P97-051 CADILLAC DRIVE OFFICE BUILDING

- REQUEST:
- A. **Negative Declaration**
  - B. **Plan Review** for construction of a 17,111± square foot office building on 1.48± acres in the Shopping Center (SC-R-PUD) and Limited Commercial (C-1-R-PUD) zones.
  - C. **Variance** to encroach 5 feet into the 25 foot landscape setback along Cadillac Drive in the Shopping Center (SC-R-PUD) and Limited Commercial (C-1-R-PUD) zones.

LOCATION: 155 Cadillac Drive  
APN: 295-0020-003  
Council District 3

Exhibit 1A  
Site Plan

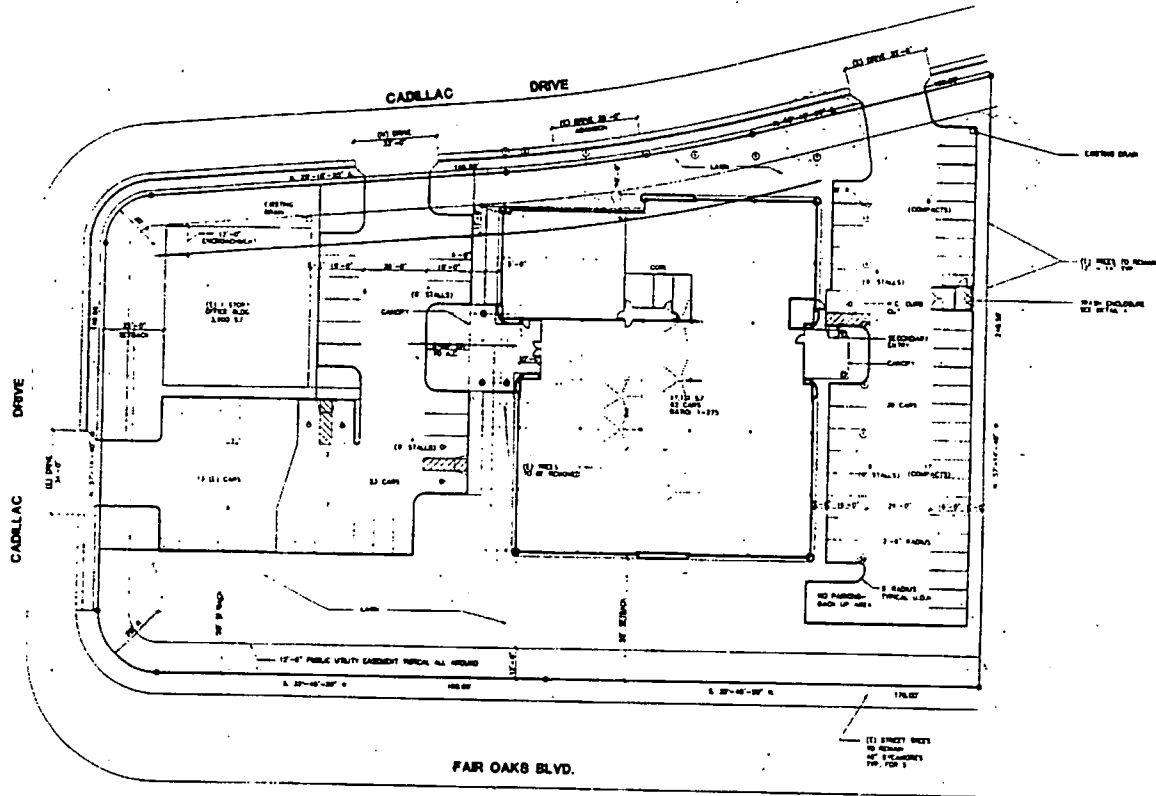
The project would encroach approximately 5 feet into the 25 foot setback on Cadillac Drive. The applicant has indicated that this is consistent with the same encroachment from the office building to the south. A site visit by staff confirmed this setback encroachment. Staff also found that the existing Key Largo restaurant structure on this site encroaches into the setback. The encroachment of the buildings only occurs from the southwest corner of the building. The rest of the building is outside the setback. No evidence in previous staff reports indicates that these encroachments were approved or even mentioned.

According to the Campus Commons PUD Guidelines, the street setback "shall be a minimum of 25 feet from the top of the curb." The rationale for the setback is to provide landscaped buffers between residential areas and commercial developments. For areas adjacent to residential housing "parking lots are to be buffered by at least ten feet of landscaping. This landscaping will have a screening effect." While the project is not directly adjacent to a residential development, more than ten feet of landscaped buffer will exist between the project and Cadillac Drive. The encroachment of this building into the setback will not negate the ten foot landscaped buffer. Therefore staff can support the requested variance.

The northeast corner of the parking lot will be contained within the parking setback. According to the PUD guidelines, "the parking setback shall not be less than 25 feet and shall not exceed a maximum of fifty percent of the Fair Oaks frontage on any individual property." The project will meet this requirement.

Parking lot circulation has been reviewed by the Department of Public Works and the Fire Department. Their comments resulted in a minor redesign to allow for a fire truck "turn-around" area.

Some parking spaces may be located inappropriately. The trash enclosure should be relocated to the west of the building. These issues were addressed in a site plan redesign.

- A11. Fire sprinklers shall be installed in the new building.
- A12. The applicant shall provide documentation to the Fire Department indicating that adequate water for fire fighting is available on-site.
- A13. A fire truck "turn-around" shall be provided at the northeast corner of the parking lot. This turn-around area shall be clearly marked and maintained as a "No Parking" area.

Exhibit 1C  
North, South, East, and West Elevations

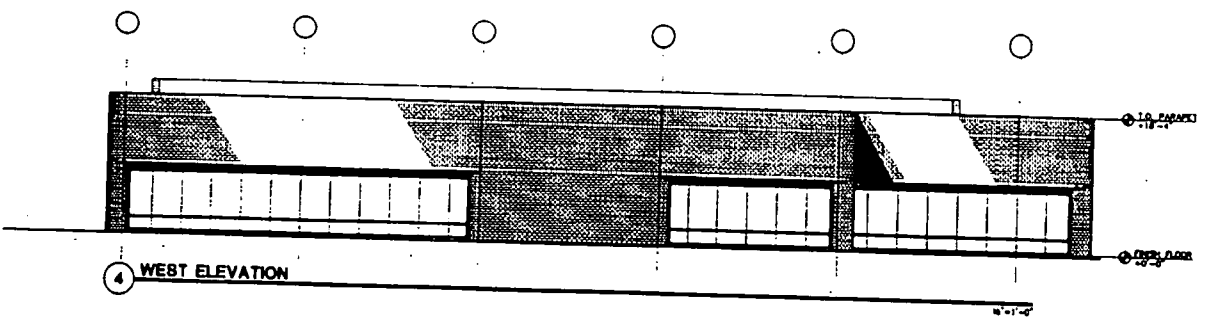
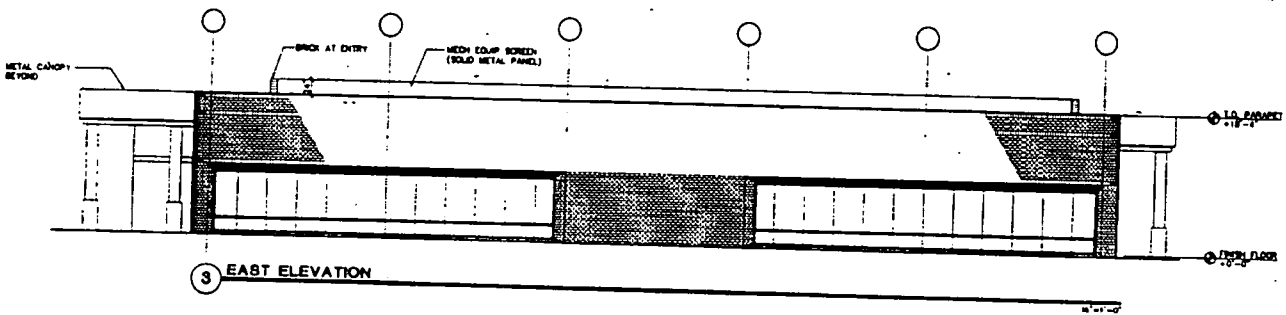
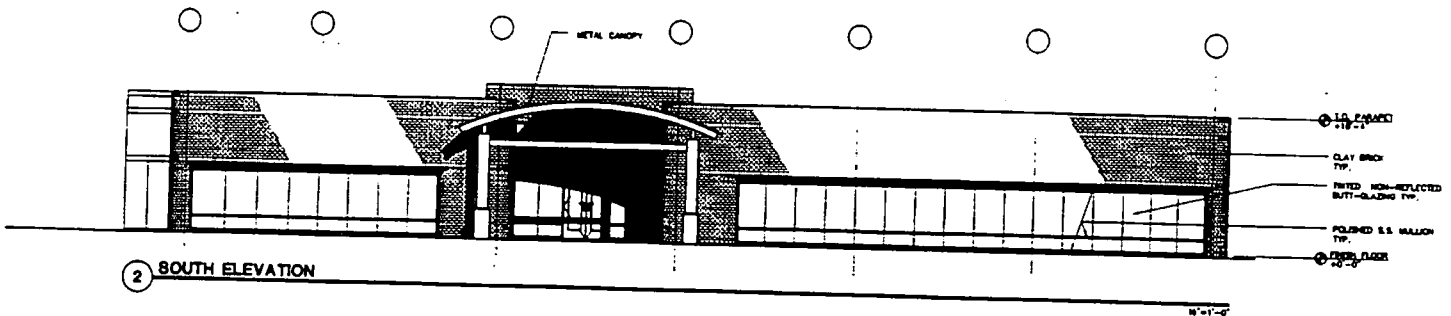
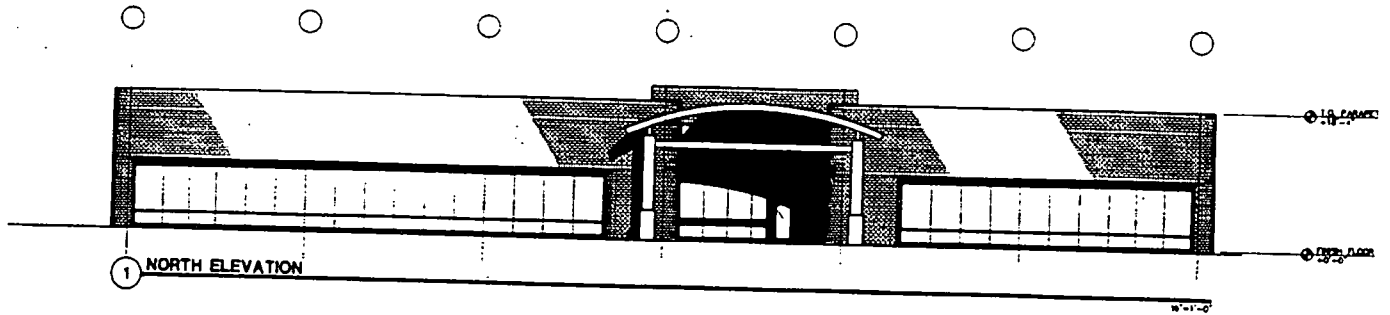
The proposed 17,111± square foot single story office building would be constructed after demolition of the unoccupied restaurant. The new building would be a one story structure, approximately 18 feet tall. The exterior would be constructed of red clay brick and non-reflective glass. The roof would be concealed by a parapet and not visible from the street. Although the project is outside the Campus Commons Design Review District, Design Review staff reviewed the originally proposed elevations and suggested changes to the applicant. The suggestions included "breaking-up" a line of windows facing Fair Oaks Boulevard, softening the building's main entrance with a canopy, and improving the rear entrance by making it more like an entrance, than just a back door. The applicant agreed to the changes and they are reflected on the attached elevations (see Exhibit 1C).
